*Environmental
Planning
Commission*

*Agenda Number: 6
Project #: PR-2023-009178
VA-2023-00246
Hearing Date: November 16, 2023*

Staff Report

The request is for a Variance-EPC to allow additional building height for a future single-family home in the Volcano Cliffs area. The subject site is the height-restriction sub-area of the Northwest Mesa Escarpment View Protection Overlay (VPO-2), and is subject to view protection regulations. Pursuant to IDO 14-16-3-6(E)(2), the purpose of this VPO is to protect views to and from the Petroglyph National Monument, which is Major Public Open Space (MPOS) found in various locations in the area.

North Elevation (looking southward)

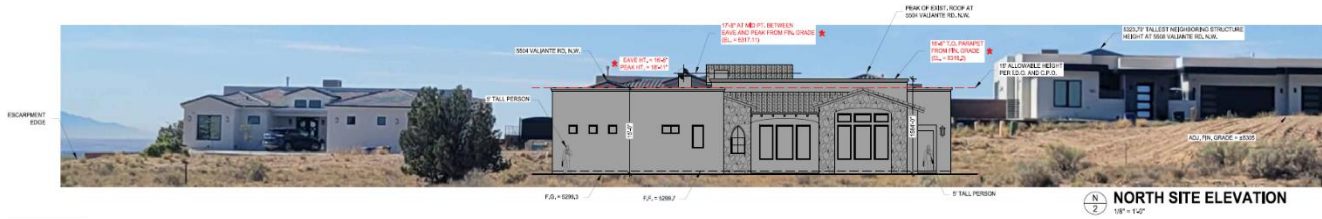
The subject site North Elevation presents the visual impact of the views looking south at the proposed single-family residential home as well as the existing homes along the southside of Valiente Rd NW. The tallest building on any abutting lot located within the Height Restriction sub-area is 5508 Valiente Rd NW. This home is 15-feet tall with a highest point in elevation of 5323.7 feet. The measured height of the proposed structure is 17 feet 8 inches at an elevation of 5316.97, which is the average height between the plate and the ridge of the gable roof. In this profile, the entire structure sits at least 9.6 inches above the 15-foot allowable height per the IDO, with about a quarter of the structure outline reaching 18 feet 11 inches in height above the finished pad, but still within the variance maximum.

East Elevation (looking westward)

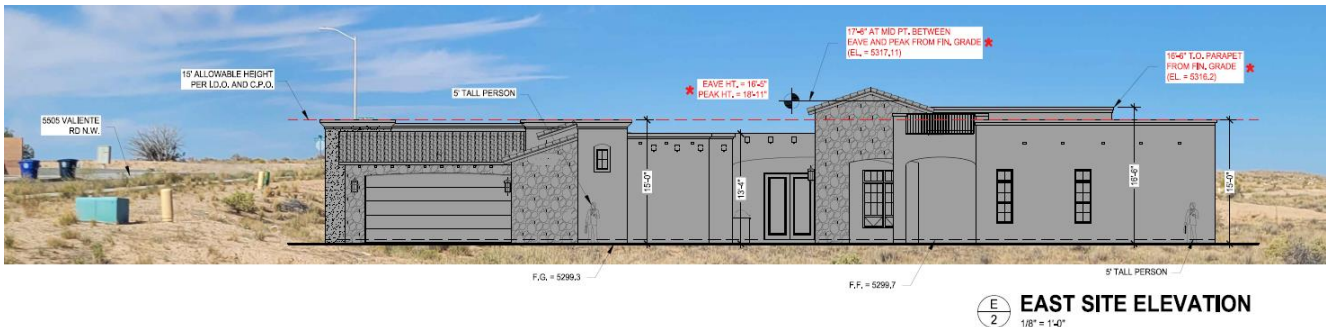
The East Site Elevation illustrates the proposed structure when looking west from offsite. The entire length of the structure rises above the 15-foot allowable height per the IDO but remains below the 19-foot Variance maximum. Given a variance, almost a quarter of the length of the structure would sit at 16 feet 6 inches or taller above the finished pad. Since the highest portion (18 feet 11 inches) of the house is oriented east-west, the tallest peak minimally impacts views. A hill slopes upwards to the west, which can be seen to either side of the proposed structure. There are no major public views in this direction.

North-South Site Section (East/West): View to the West

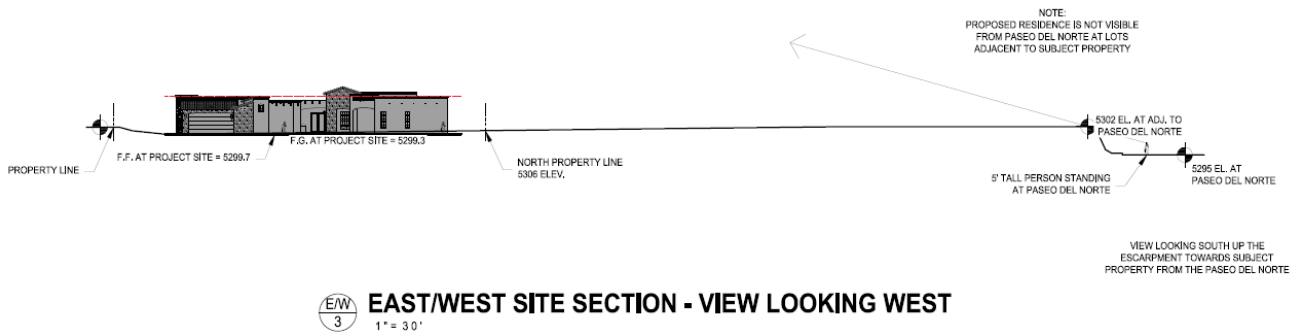
The applicant East/West Site Section shows the subject site cross section in profile south to north across the subject site to Paseo del Norte Blvd NW. The section demonstrates that subject site lies within 250 feet from the Paseo del Norte road edge, although the natural escarpment lies further to the NW.

East-West Site Section (North/South): View to the North

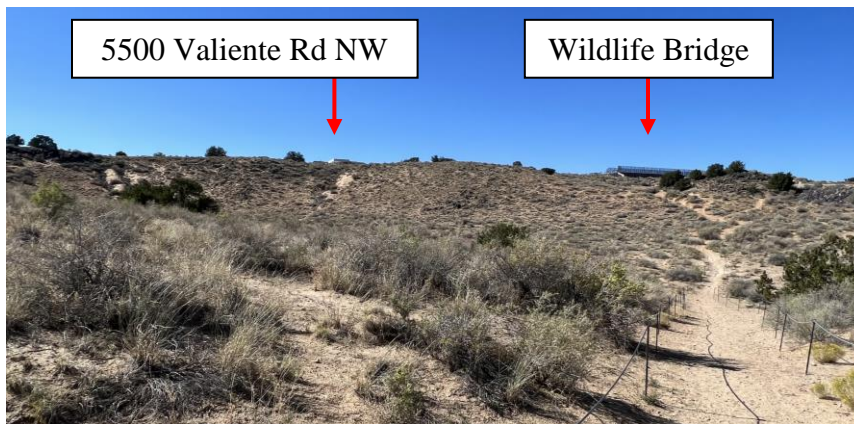
The applicant North/South Site Section cross section shows the subject site in profile, west to east, including the proposed structure, the Petroglyph National Monument Major Public Open Space escarpment, down to Cumberland Pl NW. The subject site lies approximately 565 feet from the escarpment edge plus an additional 670 feet to the nearest road below the escarpment, Cumberland Pl NW. The Monument boundary lies approximately 100 ft to the east of the proposed structure. The cross section of the terrain shows the view from the perspective of a 5-foot-tall individual looking west toward the top of the escarpment toward the proposed structure. The site section indicates that the proposed structure would not be visible from Cumberland Rd NW (See photo below: View of Escarpment and subject site from Cumberland Rd NW cul-de-sac).

Although the vertical scale is unclear in the provided section, the proposed project should allow typical views east toward the Northwest Mesa Major

Public Open Space escarpment with the presence of a structure. Standing below the escarpment to the east at the Cumberland Rd NW cul-de-sac, the existing home at 5500 is not distinguishable from the trees on the horizon; the wildlife bridge that passes over Paseo del Norte Blvd NW is. The proposed structure would be set further back from the ridge top and would probably remain invisible from below.
